**PUR-1378**  
**ADDENDUM NO. 3**  
**INVITATION TO BID**

**THE MARYLAND THEATRE EXPANSION  
IN HAGERSTOWN, MARYLAND**

**DATE: Thursday, March 29, 2018**

FOURTH FLOOR PLAN - MECHANICAL  
As indicated

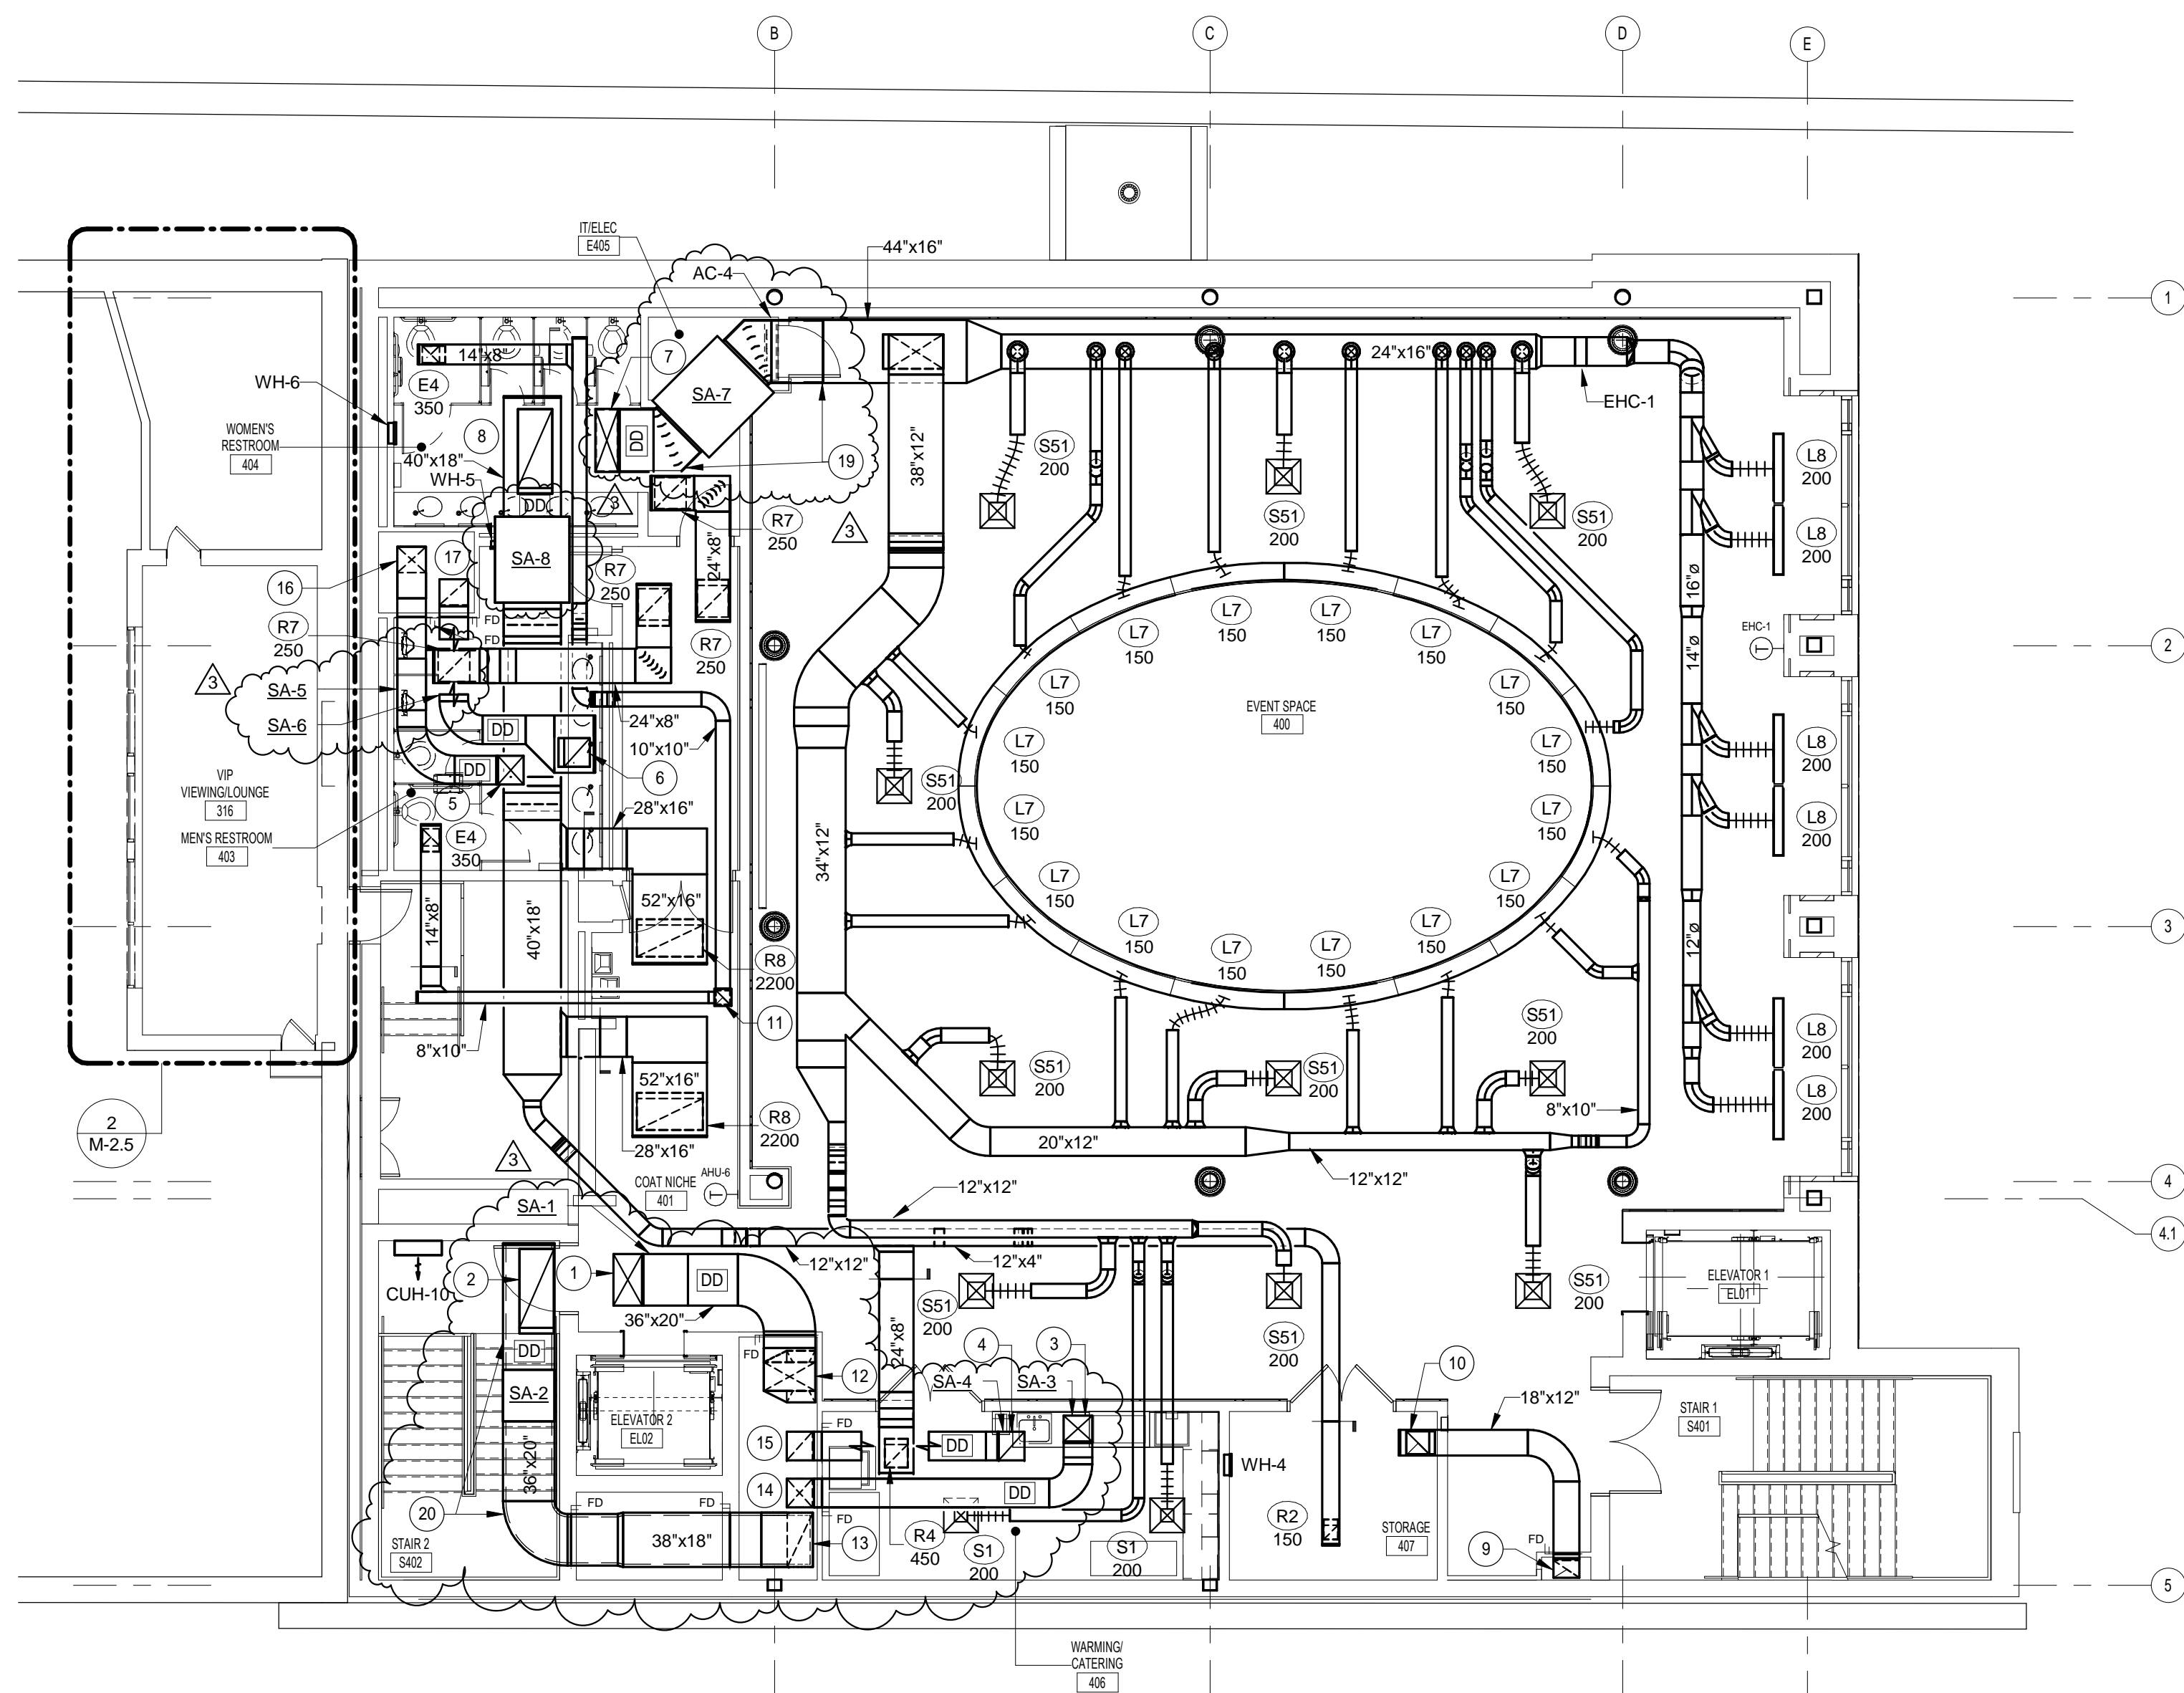
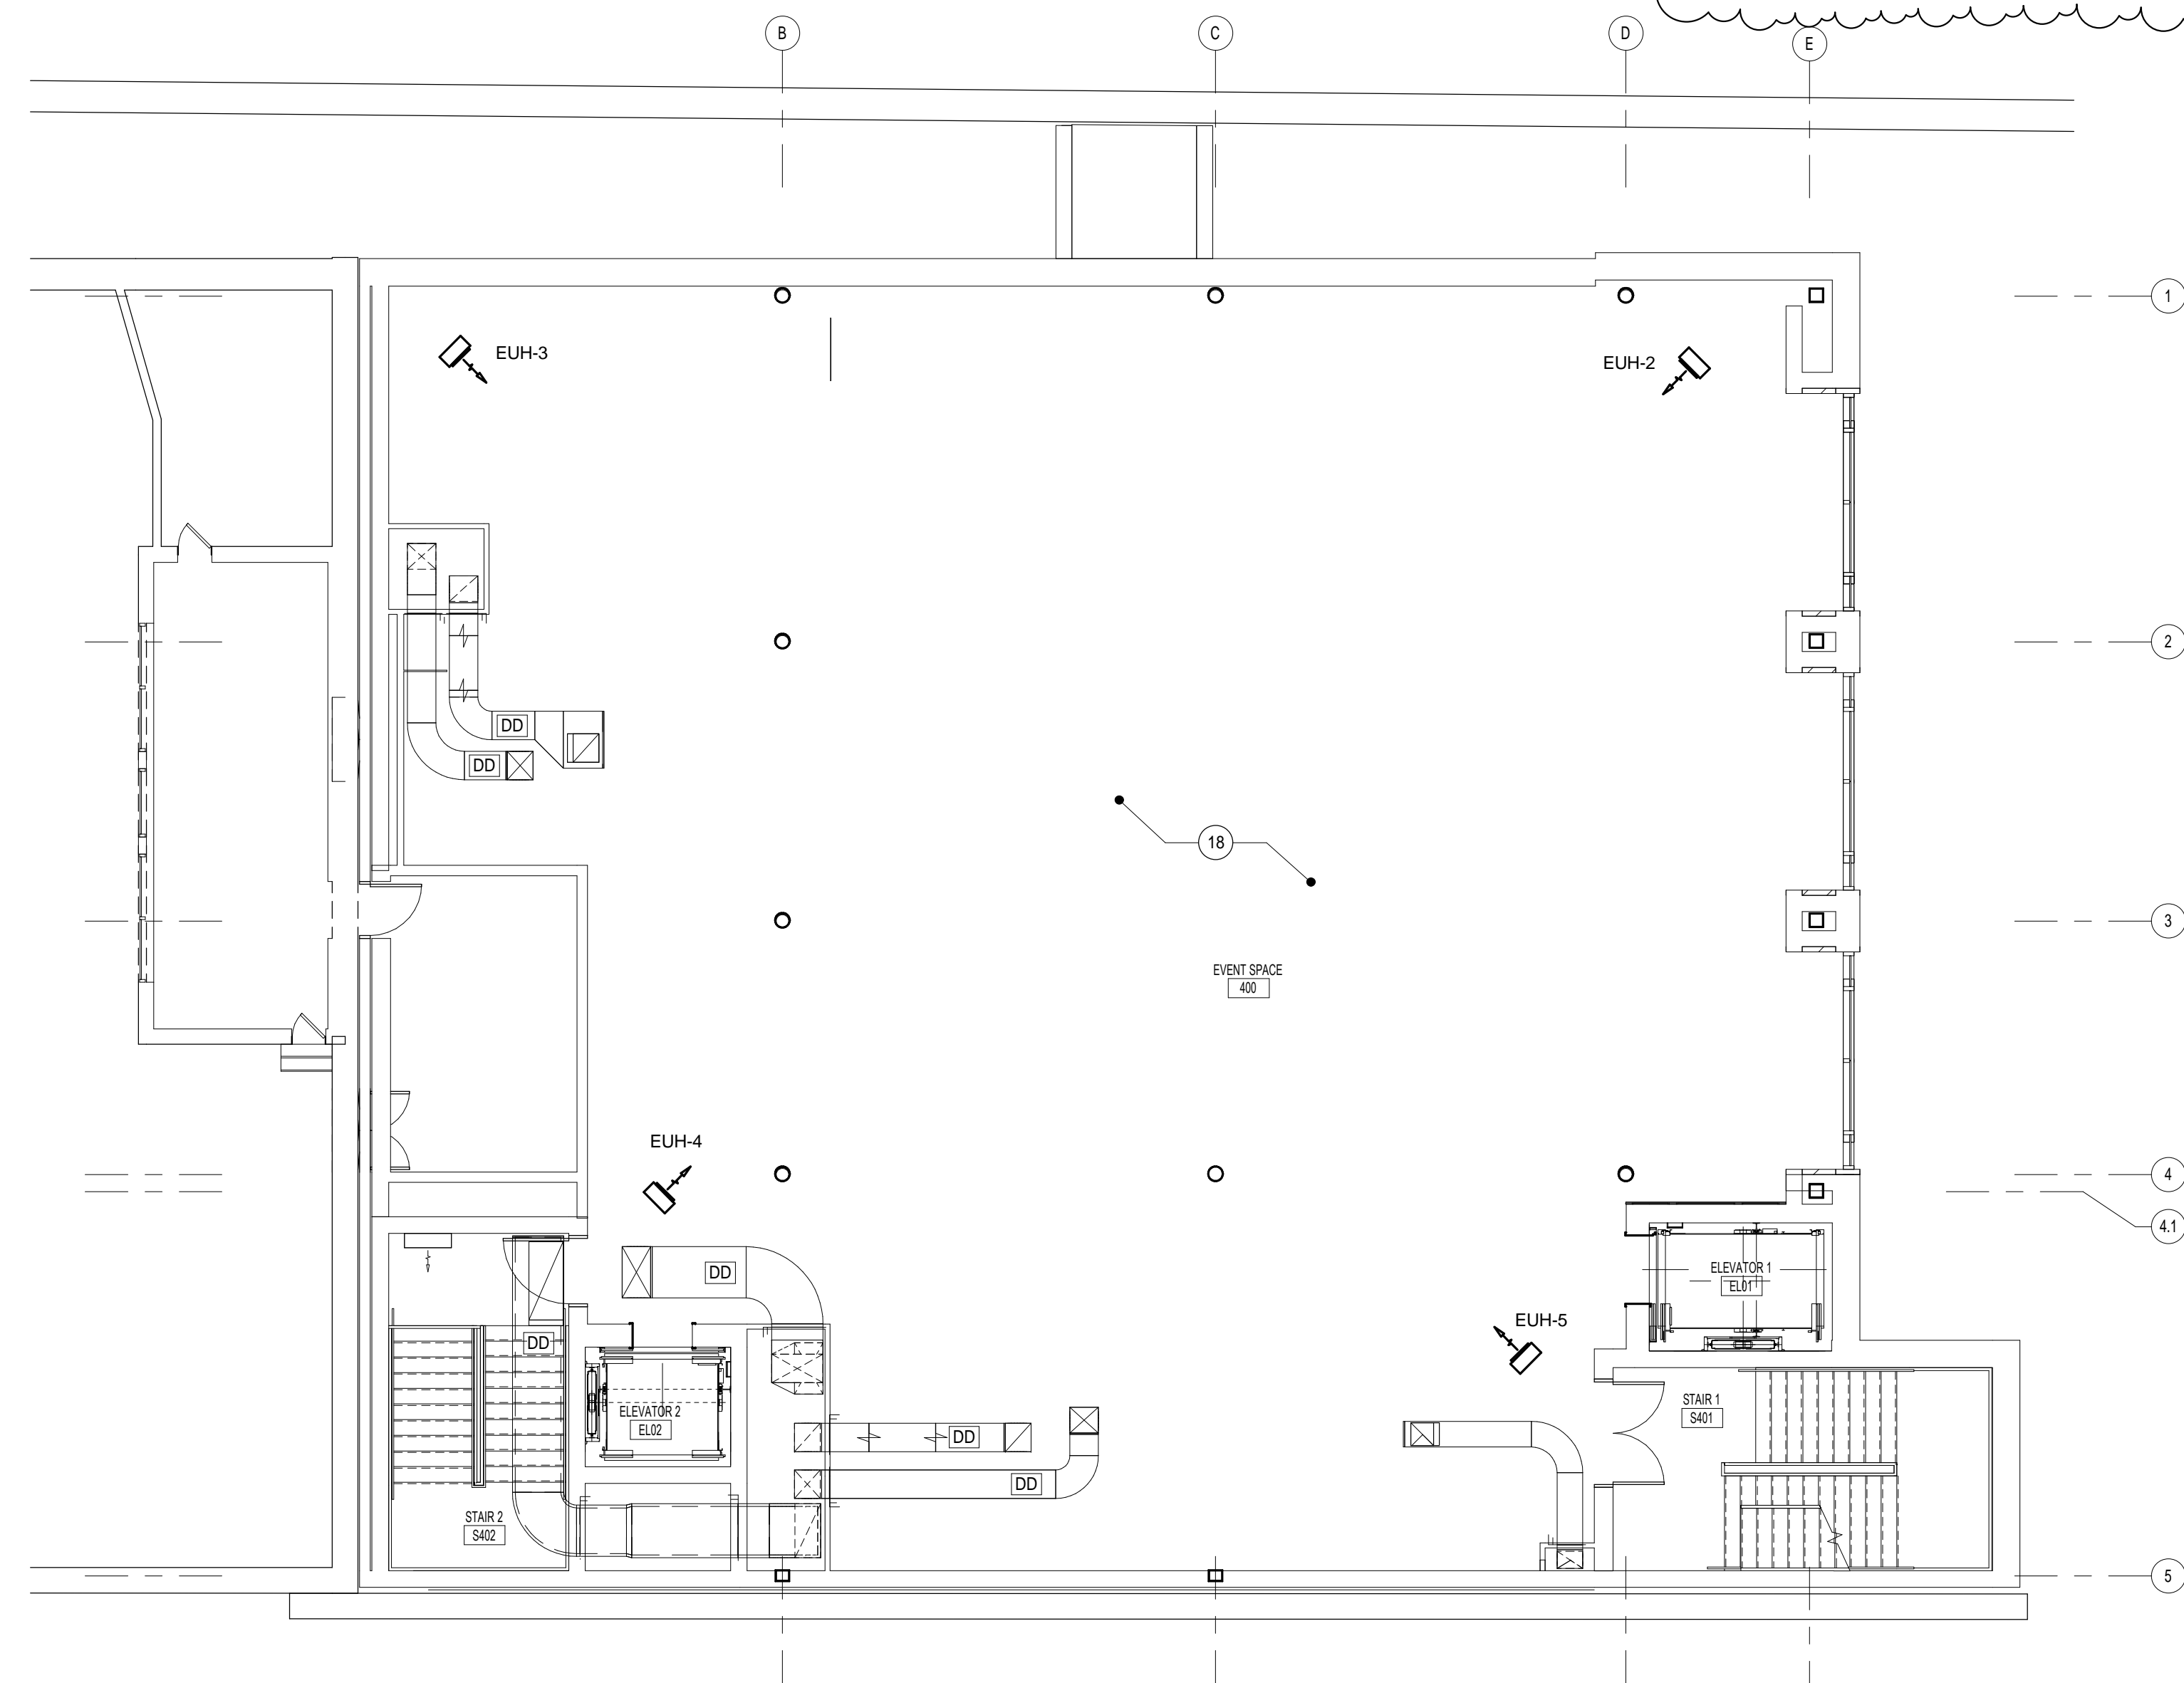
**ITEM NO. 59:**     SHEET M-2.5 – FOURTH FLOOR PLAN – MECHANICAL  
**(SHEET ATTACHED)**

**REVISE**          S/A and R/A Ductwork from RTU-4 in ceiling space and down in shaft shall be revised from 20x16 to 20x18. Revised associated drawing notes #3, 4, 14 & 15. Refer to revised sheet M-2.5 for additional information.

**ADD**             For clarity, notes and locations for all sound attenuators scheduled as indicated by SA-X, where ‘x’ is the sound attenuator number. Refer to revised sheet M-2.5 for additional information.

**REVISE**          RTU-6 unit supply connection and associated drawing note #7 to read “44x16 TRANSITION TO FULL SIZE OF RTU-6. REFER TO DRAWING M-2.6 FOR CONTINUATION.” Refer to revised sheet M-2.5 for additional information.

**ADD**             Drawing note #19. Add drawing note to revised RTU-6 supply duct near unit connection as shown on revised sheet M-2.5 for continuation.

**ADD**             Add drawing note #20. Add drawing note to RTU-3 return duct near unit connection as shown on revised sheet M-2.5 for continuation.

PROVIDE 1" INTERNAL SOUND LINING FROM UNIT CONNECTION TO SA-7, AND FROM SA-7 TO POINT SHOWN.

PROVIDE 2" INTERNAL SOUND LINING FROM UNIT CONNECTION TO SA-2, AND FROM SA-2 TO 38x18 ELBOW DN IN DUCT CHASE
